March 17, 2017

**Subject: Dam Related Engineering Services for East Goshen Township
Hershey Mill Dam (DEP ID No. D15-125)
Construction Cost Estimate for Dam Rehabilitation**

Exhibit 4
Plan View of Hershey's Mill Dam Rehabilitation (Modified)

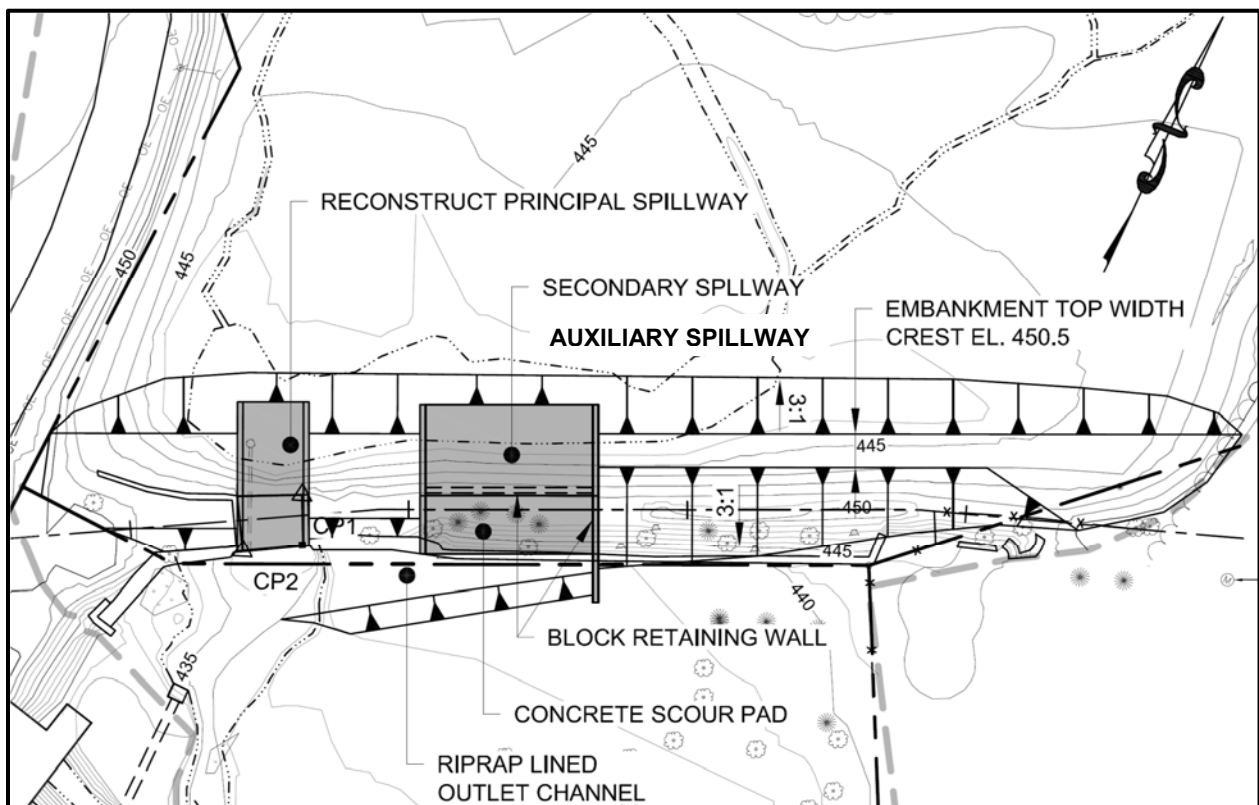
Downstream Embankment Slopes: The downstream left embankment contains steep slopes and a deteriorating hand-laid stone wall. In order to improve embankment stability, it is recommended that the slope of the downstream left embankment be reduced to 3H:1V or flatter. Shifting the embankment to the south and using slopes steeper than 3H:1V would reduce embankment earthwork costs and would be acceptable if supported by a geotechnical stability analysis.

Elimination of the Sheet Pile Support Wall: The installation of the sheet pile support wall creates a discontinuity within the earth embankment and introduces a penetration and potential seepage path through the embankment. As a cost savings and seepage reduction measure, it is recommended that the sheet pile support wall be eliminated by moving the location of the new auxiliary spillway to the left a sufficient distance such that the excavation needed to construct the foundation of this structure will not undermine the existing principal spillway. It is anticipated that the auxiliary spillway would need to be moved approximately 40 feet to the left to provide adequate separation to allow the sheet pile support wall to be eliminated (refer to Exhibit 4 for a plan view showing the relocation of the auxiliary spillway to the left).

The recommendations described above are conceptualized in Exhibits 4, 5 and 6 which provide a plan view, typical cross section through the left embankment and a typical cross section through the auxiliary spillway, respectively. The construction cost for the dam reconstruction as depicted on Exhibits 4, 5, and 6 is estimated to be between \$720,000 and \$860,000. Engineering costs to support and permit the dam rehabilitation design may be in the range of \$75,000 to \$150,000.

Exhibit 5
Typical Cross Section through Left Embankment

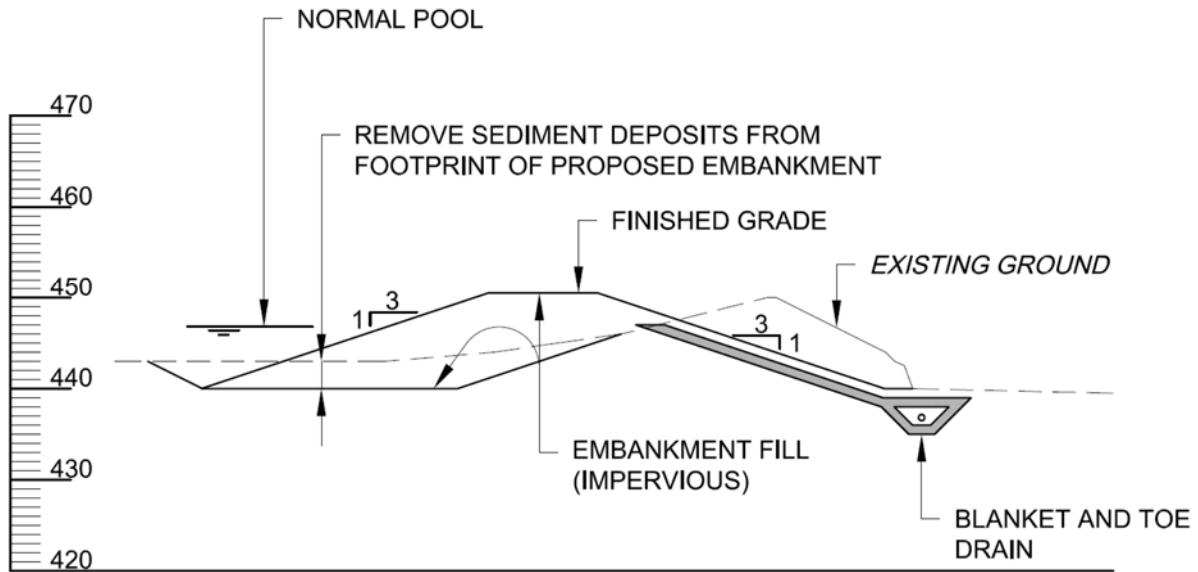
Flattening of the downstream left embankment (as described above) provides the opportunity to incorporate a blanket and toe drain system into the left embankment for collecting and filtering seepage through the earth embankment (refer to Exhibit 5). The seepage collection and filter system could also be incorporated/extended into the backfilling activities for the large block retaining wall system that supports the auxiliary spillway.

Exhibit 6
Typical Cross Section through Auxiliary Spillway

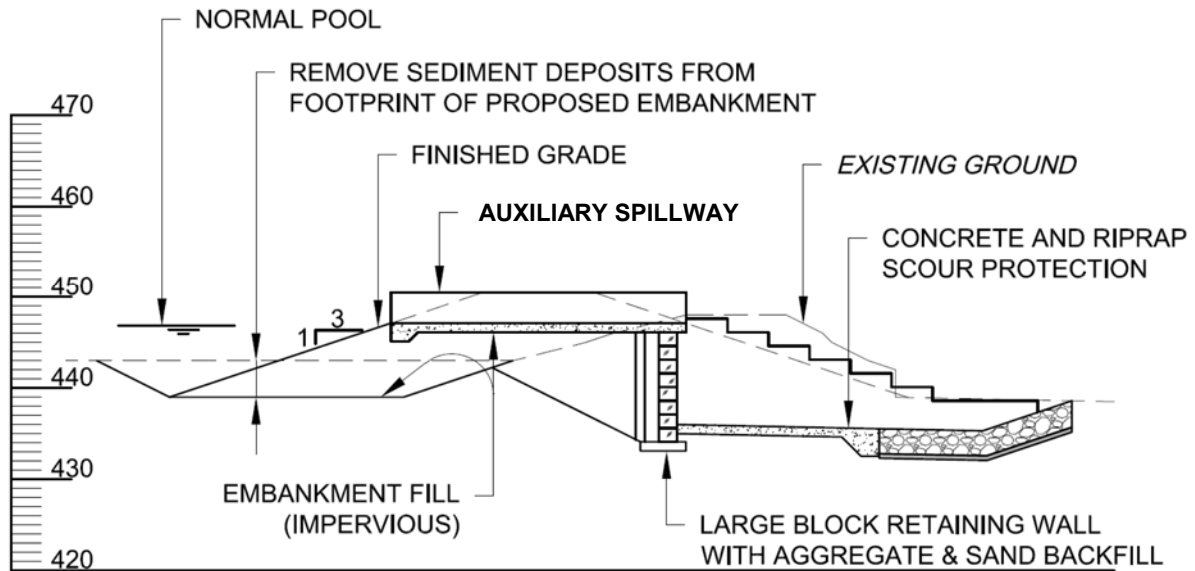
Unknown Foundation Conditions: It is unclear if subsurface investigations have been performed to sample foundation materials, locate bedrock and classify the soils located within/under the proposed auxiliary spillway. Therefore the foundation conditions for the auxiliary spillway appear to be unknown. Understanding the foundation conditions for the

auxiliary spillway is important. If the spillway is founded on erodible overburden material, which appears to be the case, the auxiliary spillway design should include a seepage analysis and would likely require a seepage cutoff wall and filtered drain system to control seepage under the structure and prevent a piping failure. If the auxiliary spillway structure is founded on bedrock, foundation treatment would include additional excavation and effort to clean and inspect the foundation rock, and place backfill concrete to the desired foundation grade. Should the Township choose to rehabilitate Hershey's Mill Dam, it is recommended that a geotechnical subsurface exploration program be implemented to verify the existing site conditions and support the design of the proposed improvements.
